Appendix B: Existing and Proposed Development Drawings

Saville Theatre

EWP Mark-Up

Mark-Up Title: Pile Loads

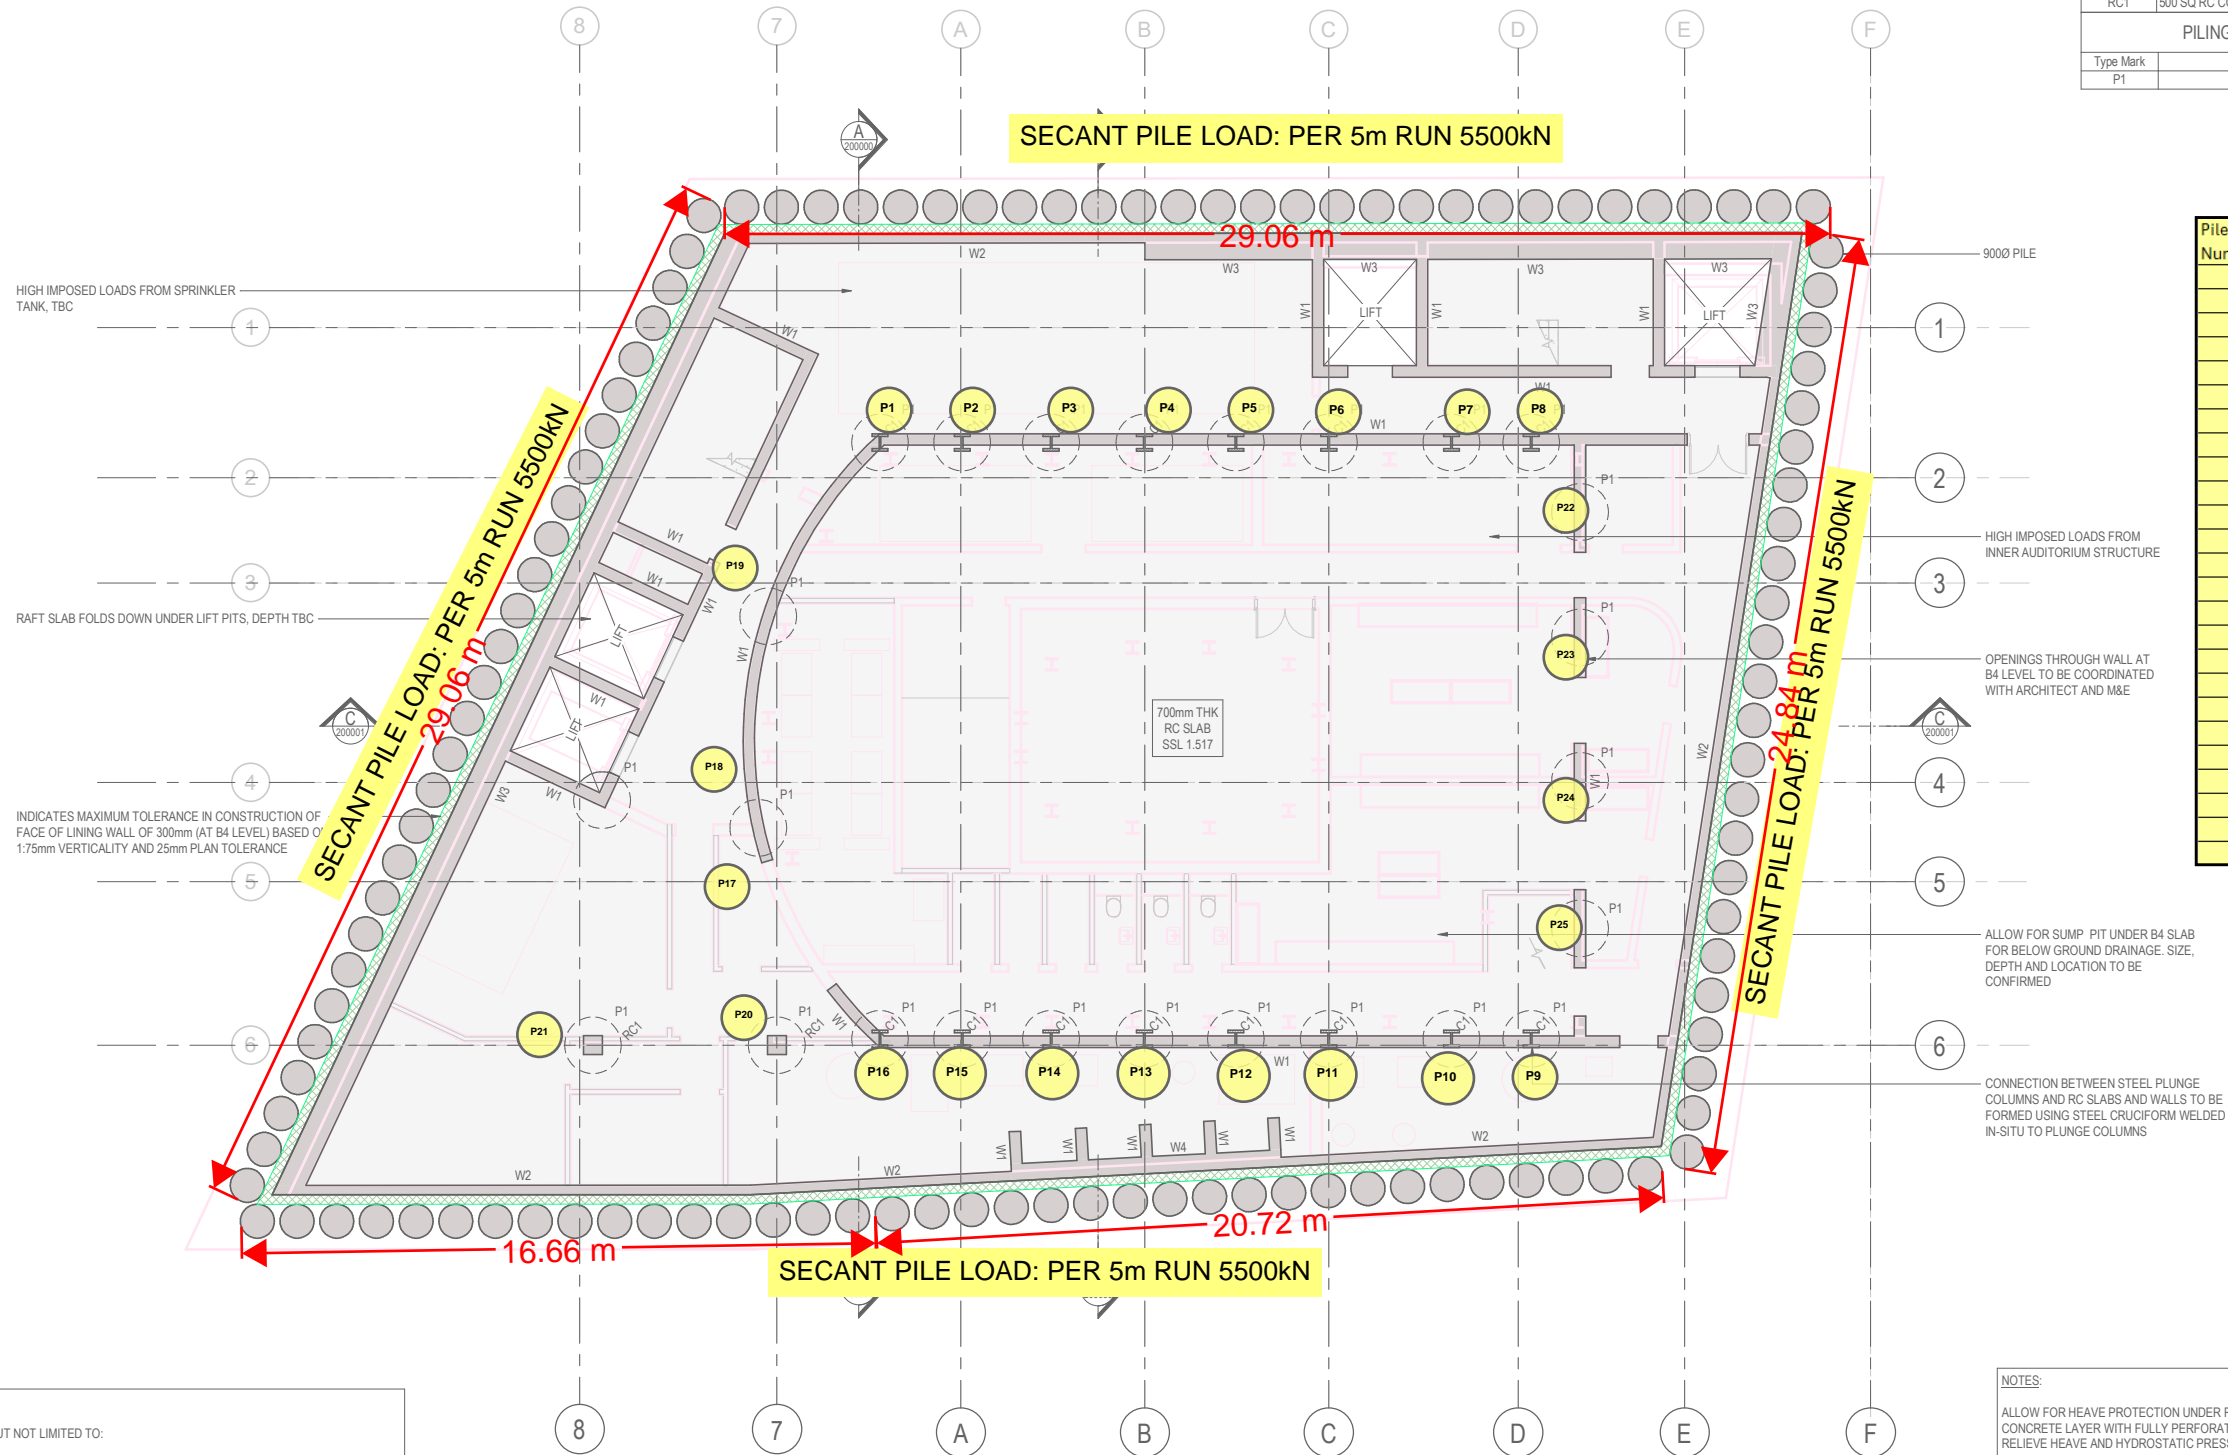
ALLOW FOR HEAVE PROTECTION UNDER RAFT SLAB AND NO FINES CONCRETE LAYER WITH FULLY PERFORATED DRAINAGE PIPES TO RELIEVE HEAVE AND HYDROSTATIC PRESSURES, TBC

ALL BASEMENT LAYOUTS UNDER COORDINATION

ALL PILE SIZES SHOWN INDICATIVELY. PILE DESIGN BY CONTRACTOR

ALL STRUCTURAL SIZES FOLLOWING DEVELOPMENT STAGE 3.

BASEMENT WATERPROOFING UTILISE WATER RESISTANT DRAIN.

DESIGN OF STRUCTURAL WORKS BY CONTRACTOR. WALLS, CONSTRUCTION AND PROPPING SEQUENCE TO BE DEVELOPED AT STAGE 3.

EXISTING STRUCTURE INFORMATION AND IS TO BE COORDINATED WITH ARCHITECT.

Drawing title
Site Section - Proposed Building

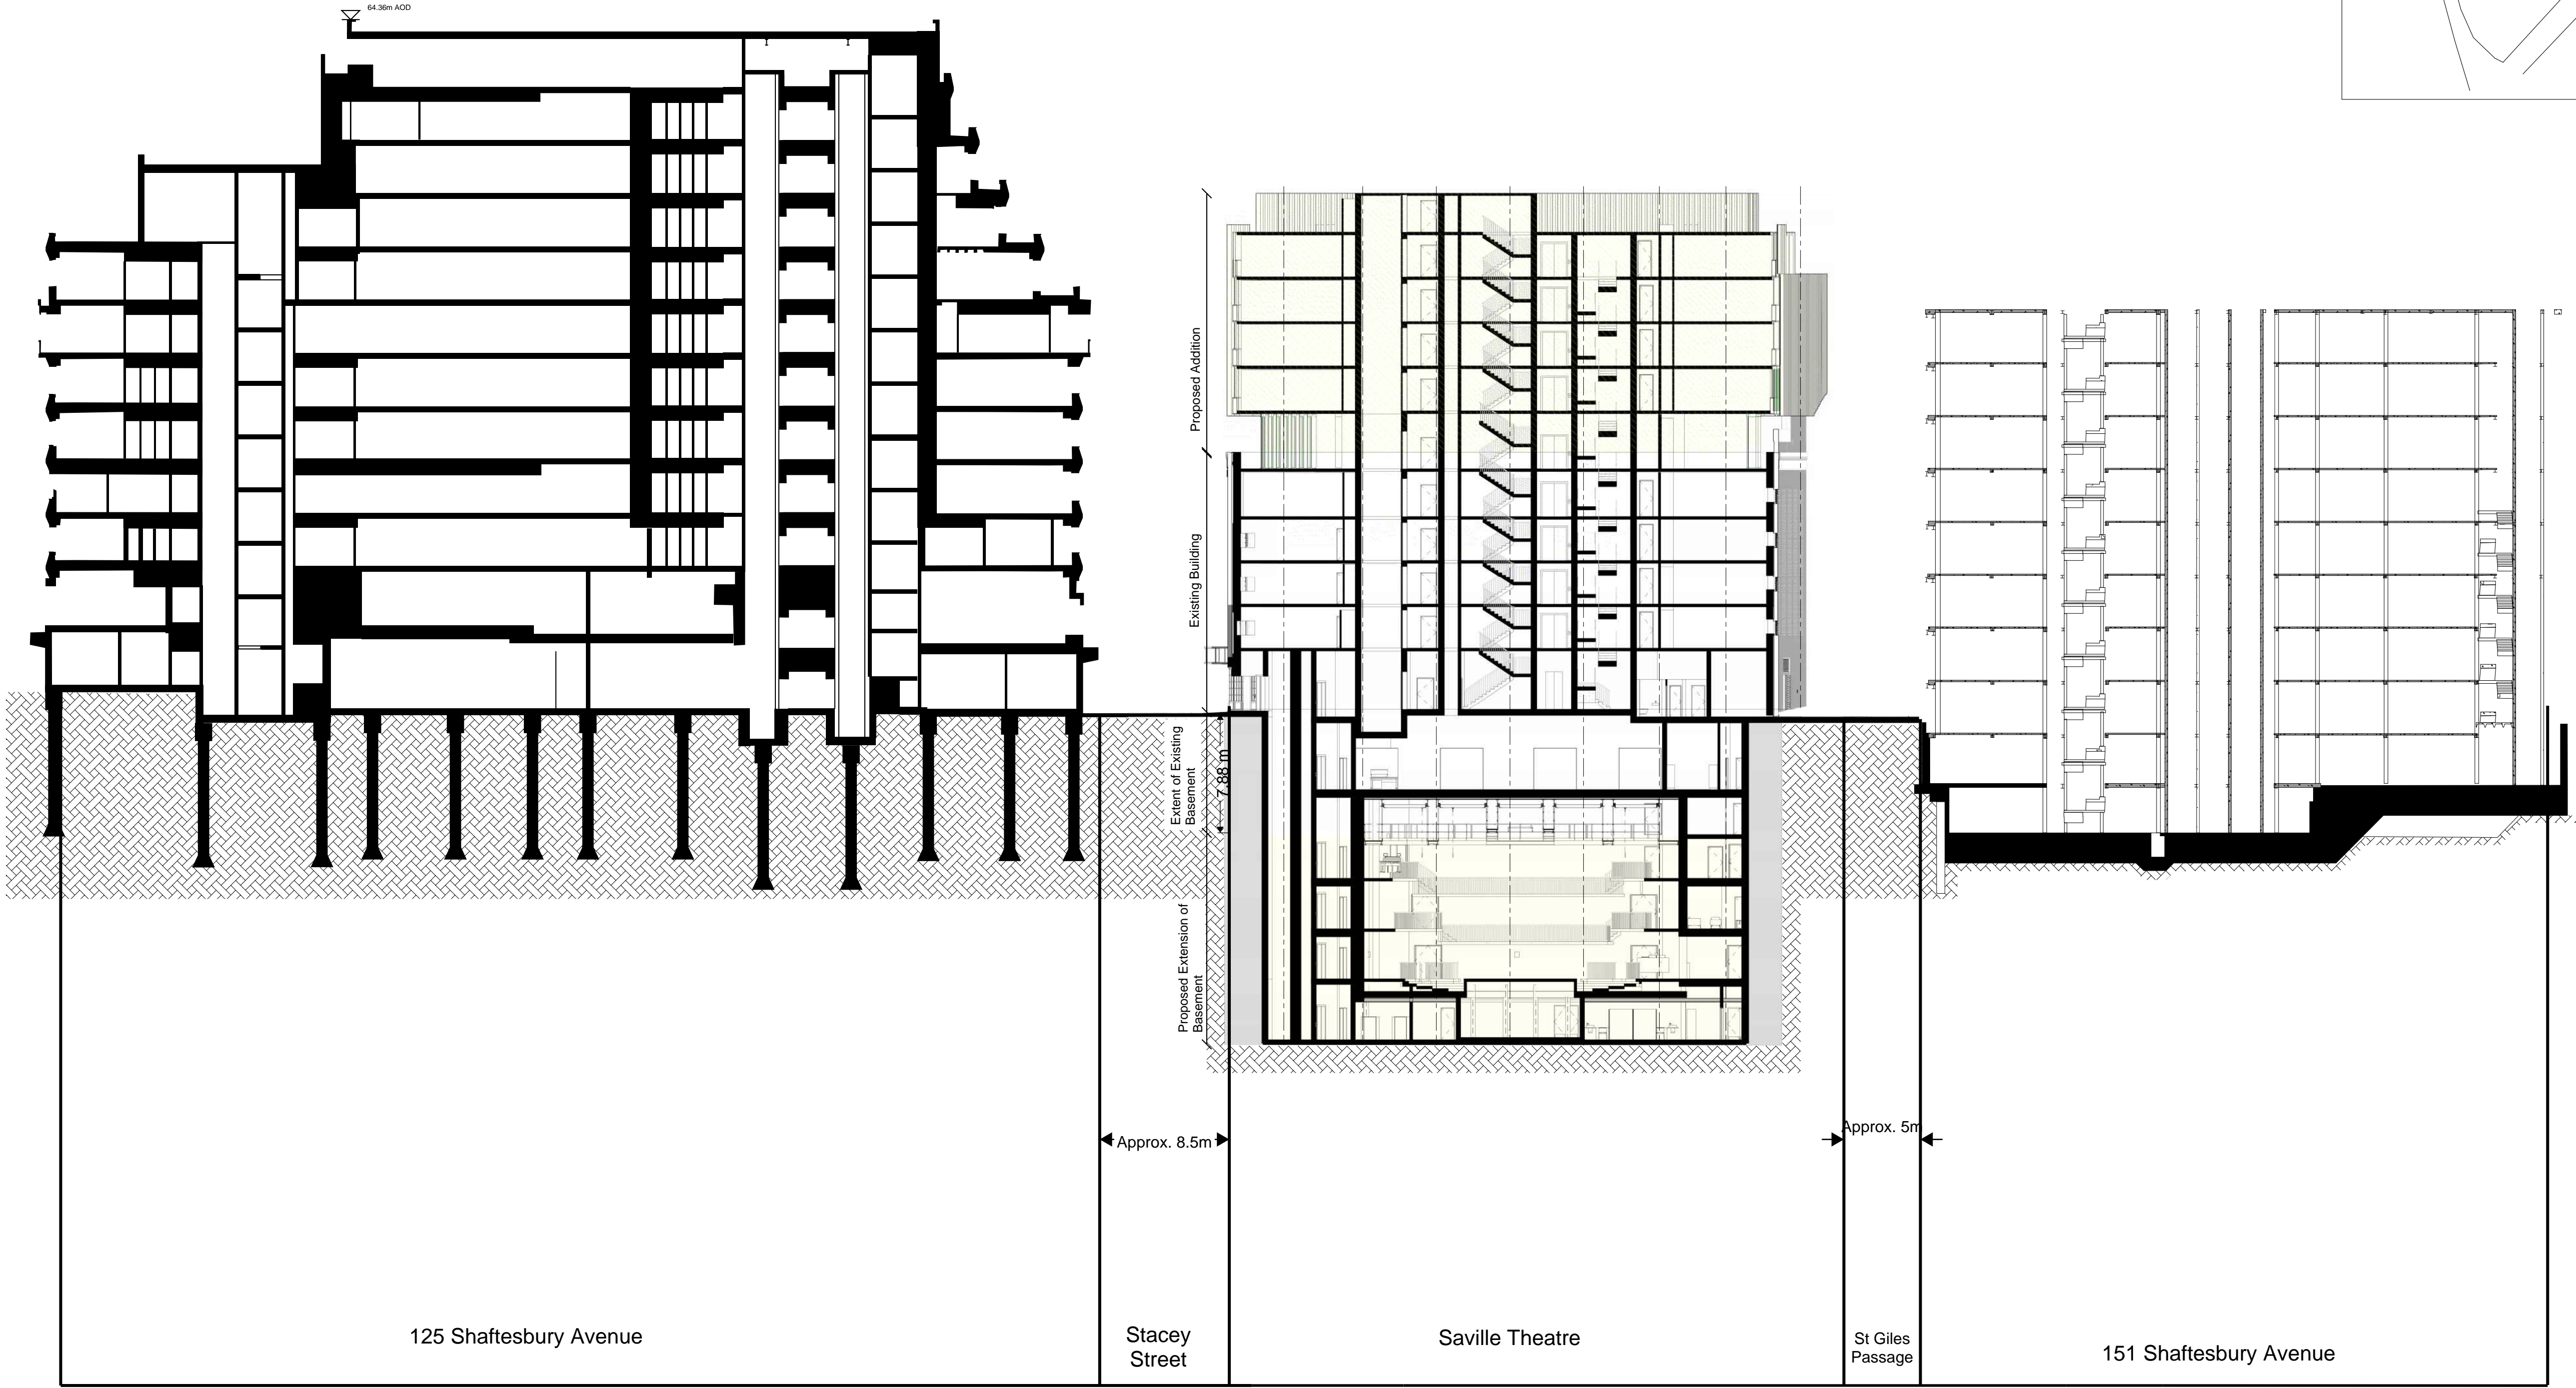
Level	Area	DL	LL	Total
RF	270	7	5	3240 kN
5	840	7	5	10080 kN
4	702	7	5	8424 kN
3	295	7	5	3540 kN
2	552	7	5	6624 kN
1	260	7	5	3120 kN
0	840	7	5	10080 kN
B1	540	7	5	6480 kN
B2	770	17	5	16940 kN

Walls	Length	Height	thick	
Façade	120	19	0.33	13543.2 kN
Basement walls	120	6	0.8	14400 kN

Total: 96471.2 kN

Area load: 111 kN/m2

robot model	Basement	86750 kN
robot model	Superstructure	81258 kN
	TOTAL	168008 kN

Proposed B4 Level Plan

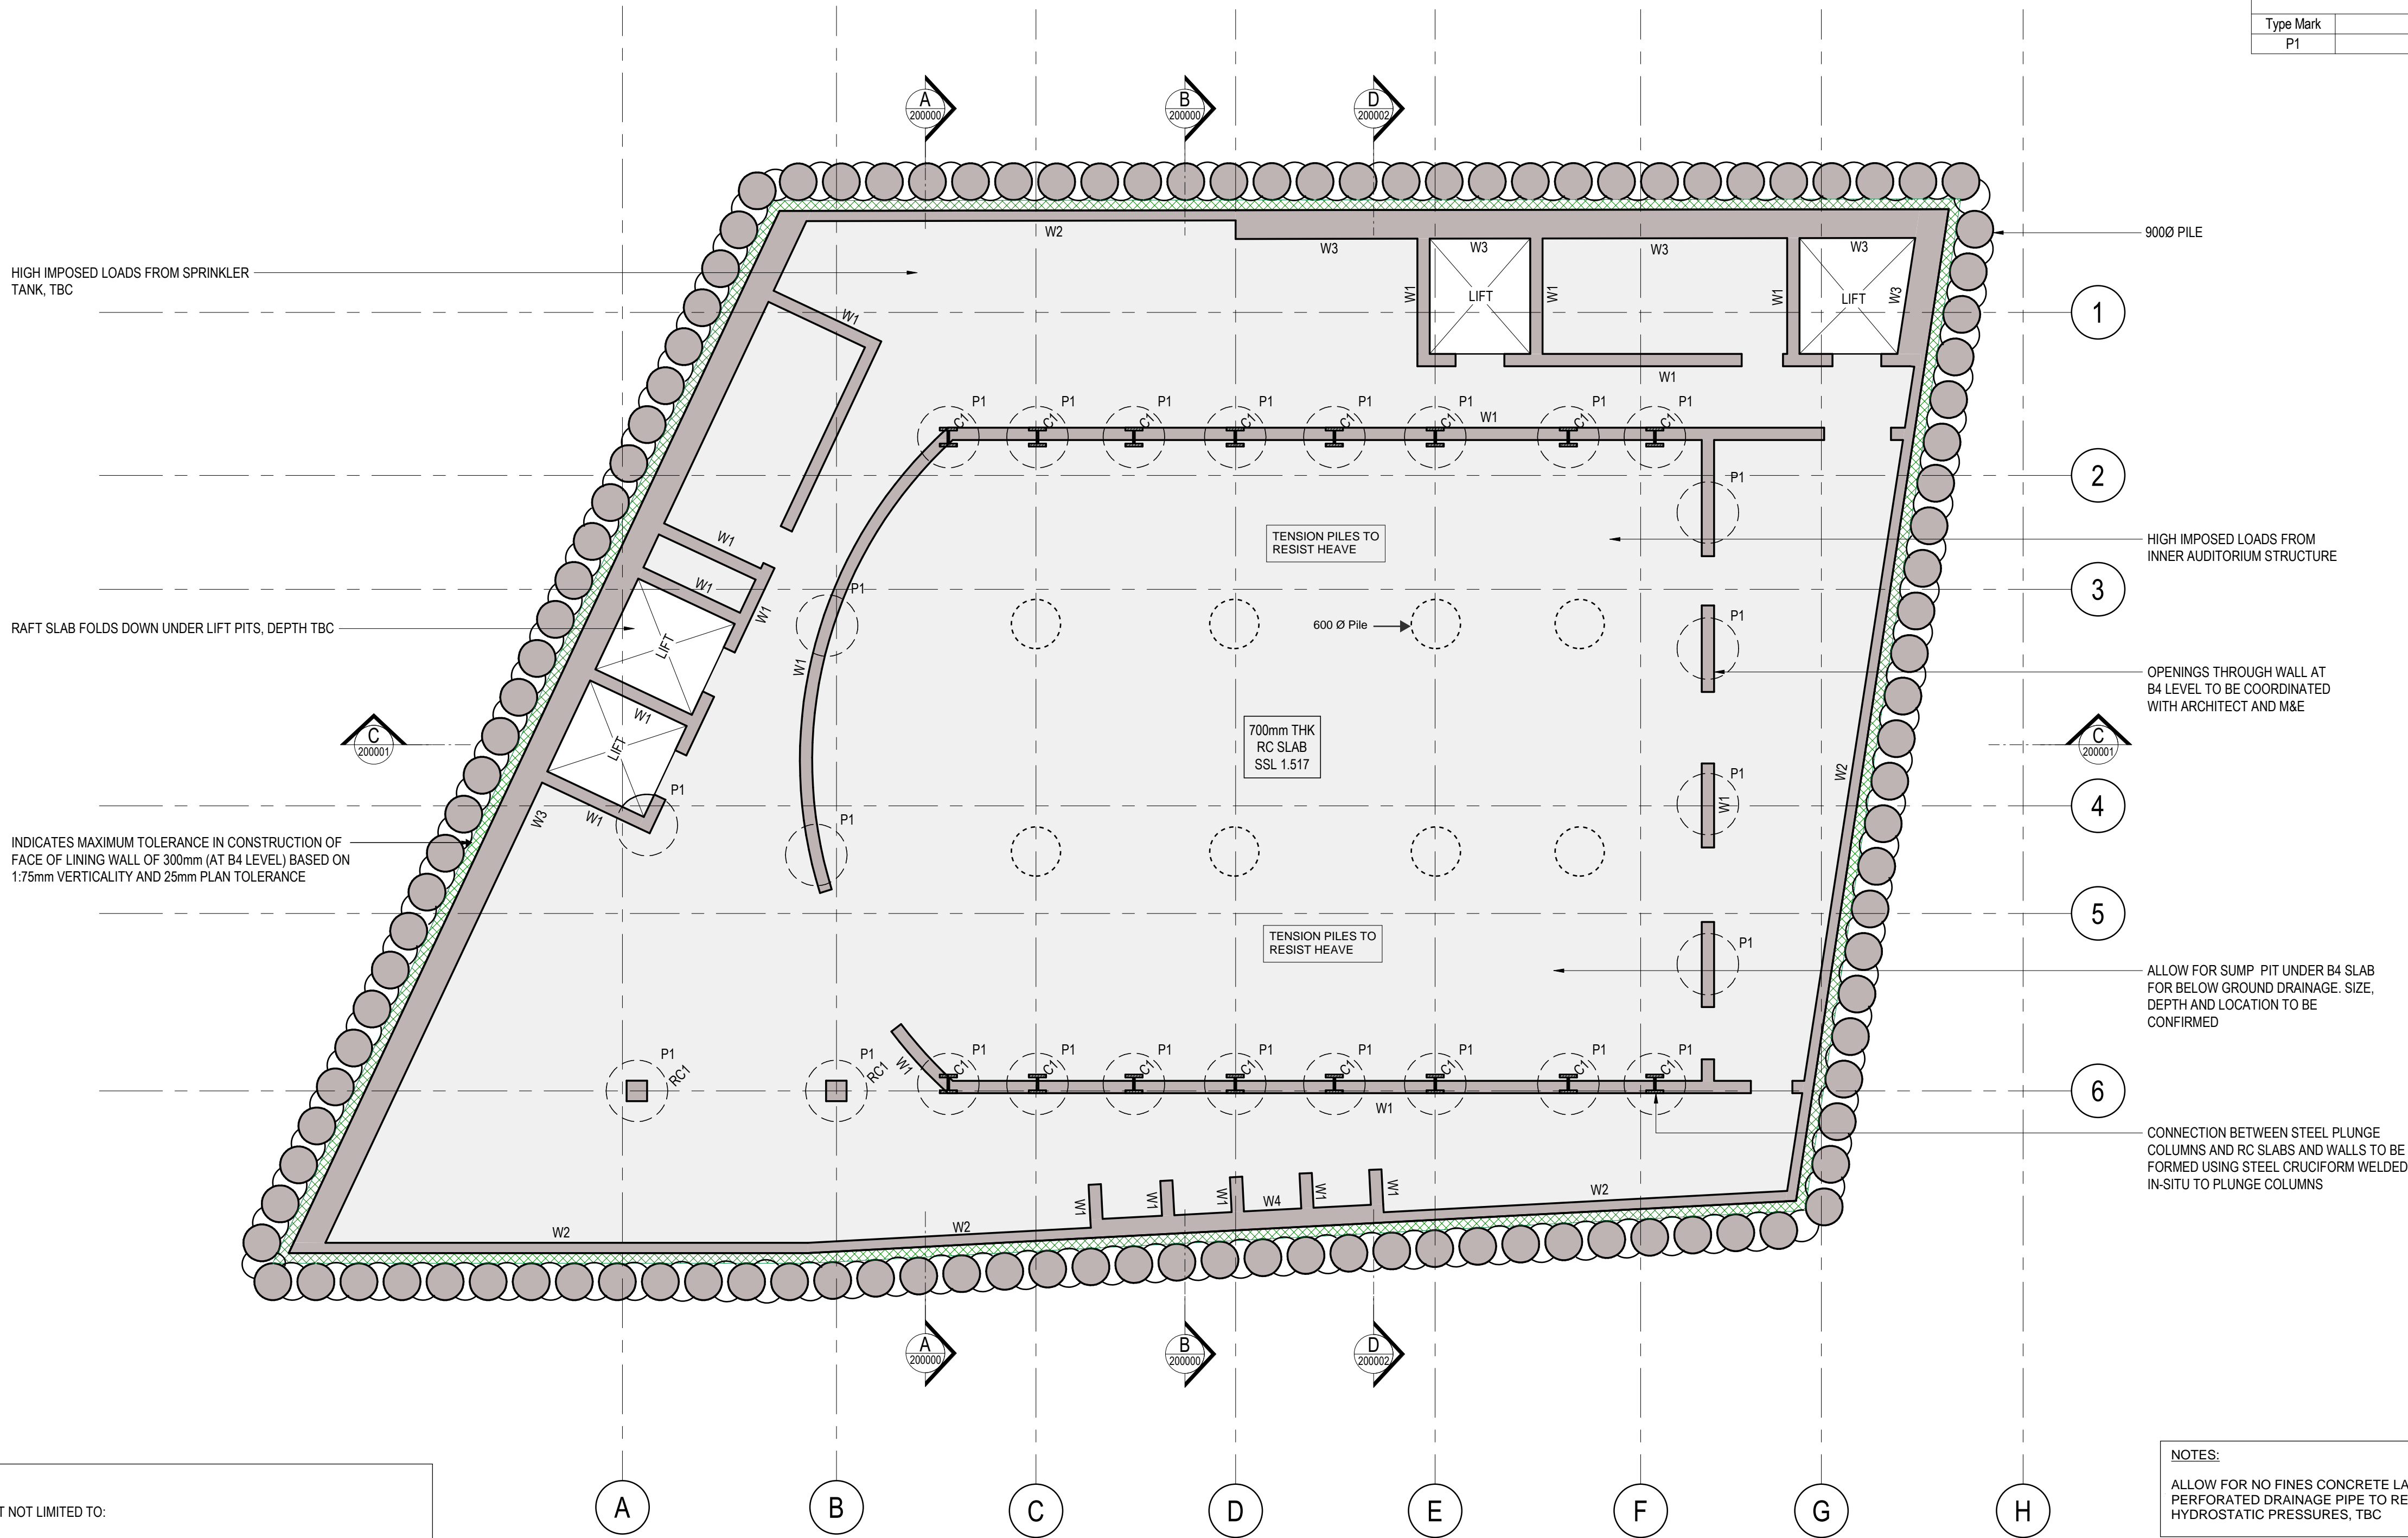
HIGH IMPOSED LOADS FROM SPRINKLER TANK, TBC

RAFT SLAB FOLDS DOWN UNDER LIFT PITS, DEPTH TBC

INDICATES MAXIMUM TOLERANCE IN CONSTRUCTION OF FACE OF LINING WALL OF 300mm (AT B4 LEVEL) BASED ON 1.75mm VERTICALITY AND 25mm PLAN TOLERANCE

TENSION PILES TO RESIST HEAVE

TENSION PILES TO RESIST HEAVE

HIGH IMPOSED LOADS FROM INNER AUDITORIUM STRUCTURE

OPENINGS THROUGH WALL AT B4 LEVEL TO BE COORDINATED WITH ARCHITECT AND M&E

ALLOW FOR SUMP PIT UNDER B4 SLAB FOR BELOW GROUND DRAINAGE. SIZE, DEPTH AND LOCATION TO BE CONFIRMED

CONNECTION BETWEEN STEEL PLUNGE COLUMNS AND RC SLABS AND WALLS TO BE FORMED USING STEEL CRUCIFORM WELDED IN-SITU TO PLUNGE COLUMNS
